E130-21

Proposed Change as Submitted

2021 International Building Code

Transfer shower

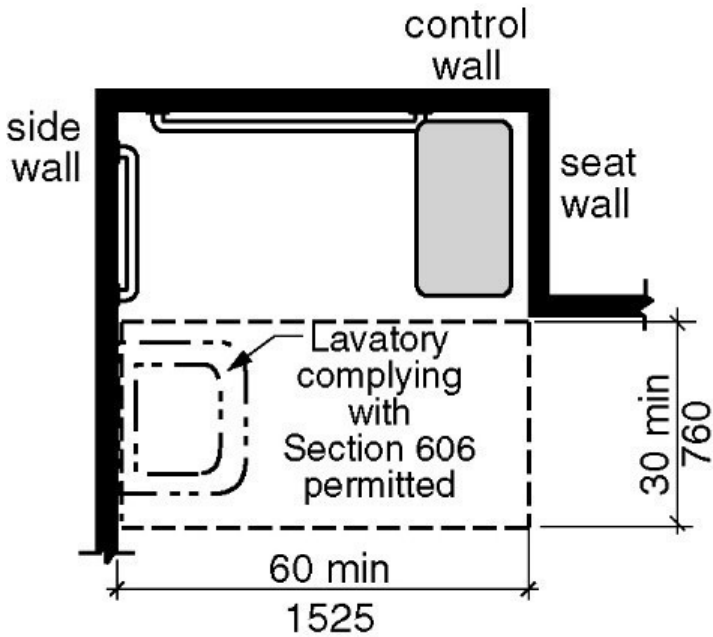
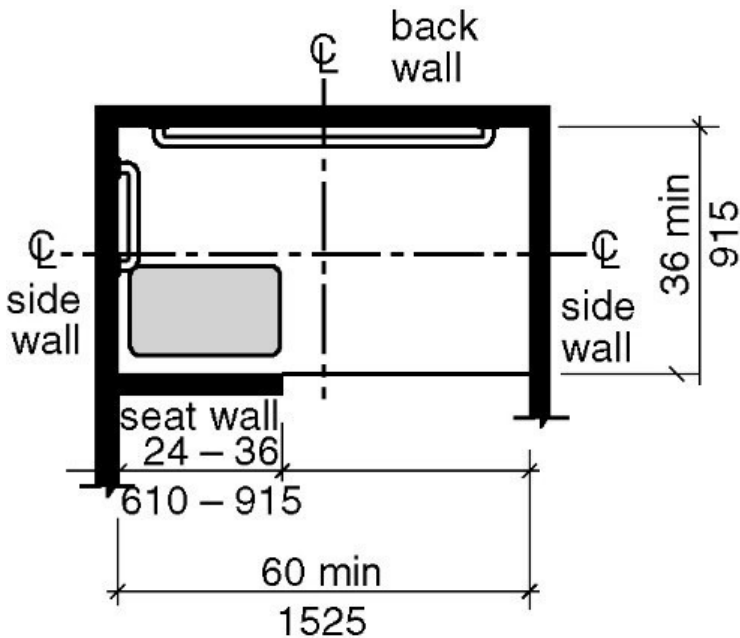
Reason: If a hotel has all showers, Table 1107.6.1.1 could be read to force bathtubs in Accessible rooms. What is the reasoning/justification for this? A roll-in shower with a seat is doing double duty as transfer and roll-in. The table was written originally with the intent to require at least some roll-in showers when hotels typically provided all bathtubs. Designs for bathrooms have changed. Providing showers instead of tubs has been shown to reduce accidental falls in the bathrooms; while continuing to provide accessible options.

The proposal asked a rhetorical question regarding what the reasoning/justification was for requiring bathtubs. It also made an incorrect statement and equating a roll-in shower with a transfer shower. It is clear that neither the BCPC nor the hearing committee investigated this or contacted the US Access Board for direction. Bathtubs are better when an adult is assisting in bathing a disabled child. Additionally, some adults prefer a bathtub if they can accomplish the transfer because they can use the shower wand and adjust the distance to it by placing the seat where desired.

- *A roll-in shower with a seat is doing double duty as transfer and roll-in.* Response: A roll-in shower differs significantly from a transfer shower. One of the main differences is that a person using a shower wheelchair cannot remain in the wheelchair while showering because it will not fit into the shower. The ability to remain in the wheelchair allows people whose disabilities affect their balance greater safety by avoiding a transfer and avoiding a seat that is not tailored to their disability needs. The additional space in a roll-in shower with a seat can present challenges to people who need to brace themselves against the opposite wall for stability.

Committee Reason: The proposal was approved as this will remove the misinterpretation that a hotel has to put in accessible tubs and could not choose to provide a higher level of accessibility and safety by providing all transfer and roll-in showers in the Accessible units. (Vote: 14-0)
